## Note on using PRIMERGY TX150 S6

June 2008  
FUJITSU LIMITED

## 2. Updates for "PRIMERGY TX150 S6 User's Guide"

#### ■ Attaching covers (Page 116)

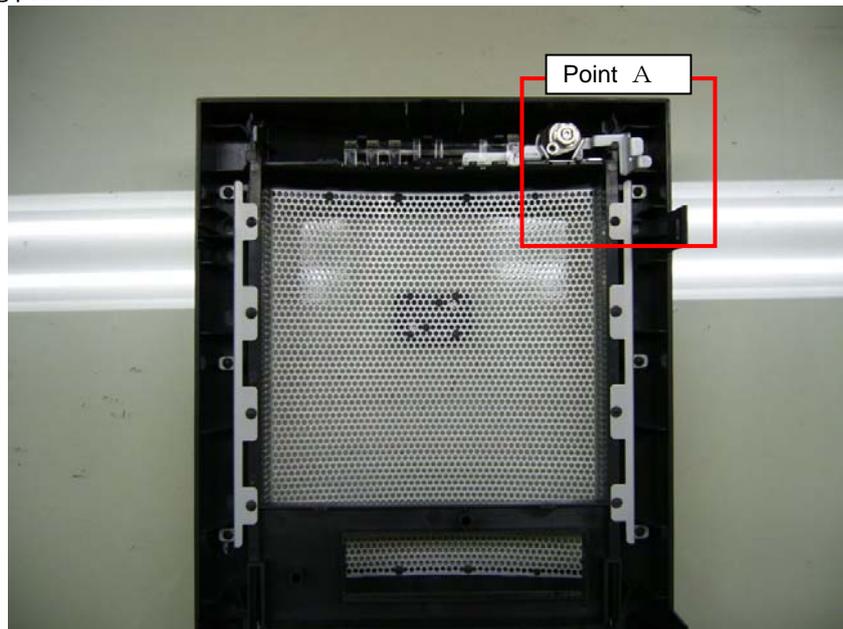
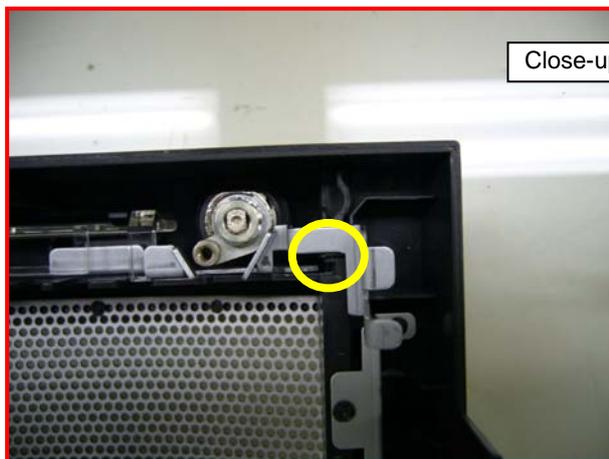
**Addition** Following caution notes are added for attaching the cover description.

Before attaching the covers, flip the front cover and make sure the position of the key lock part (Point A) is settled at the *proper position*. If the key lock part is not at the *proper position*, resetting the part before attaching the covers are required. It may cause a breakage failure if you attach the covers and lock the key with wrong position.

## 7.2.9 Security Menu (Page. 160)

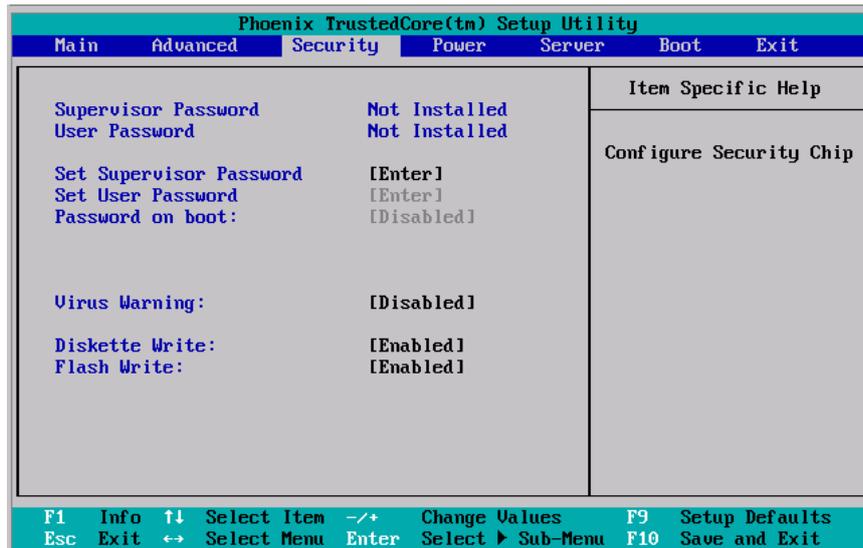
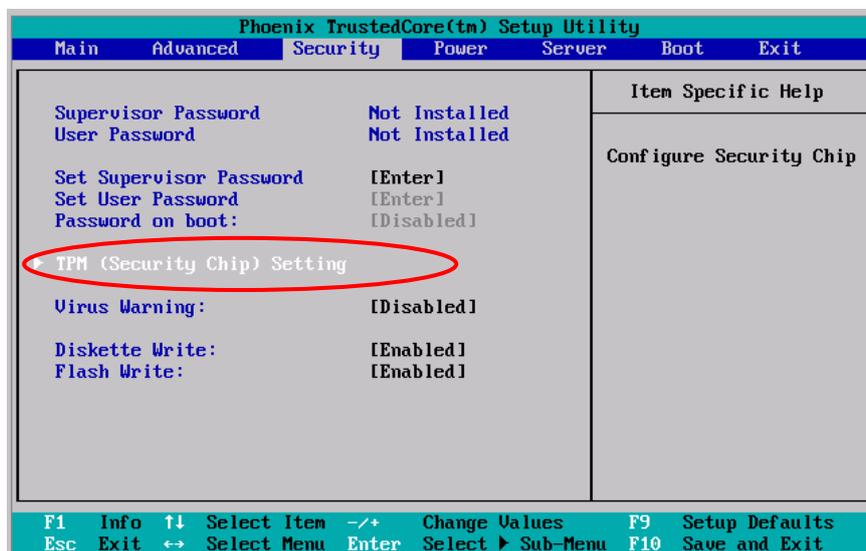
Correction

False)

True)

## 7.2.9 Security Menu (Page 161)

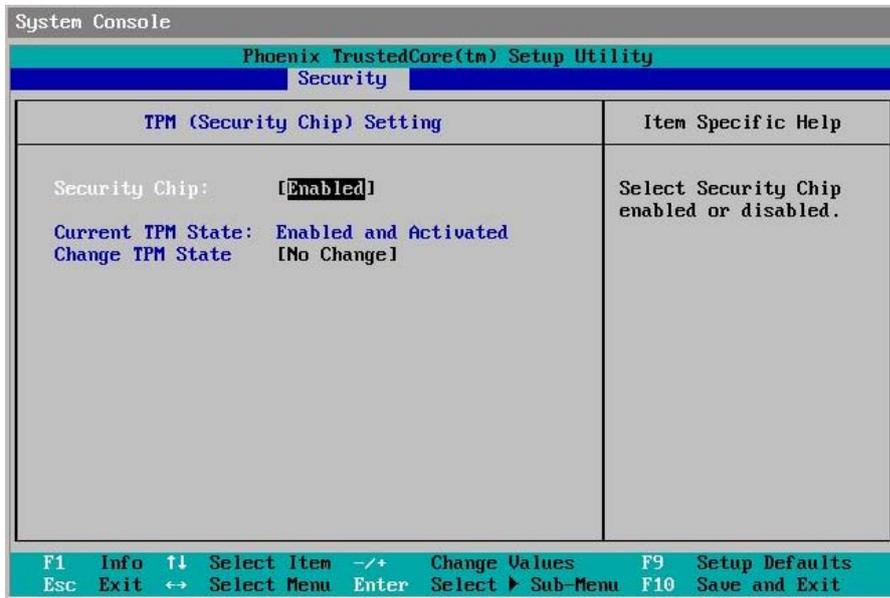
Addition
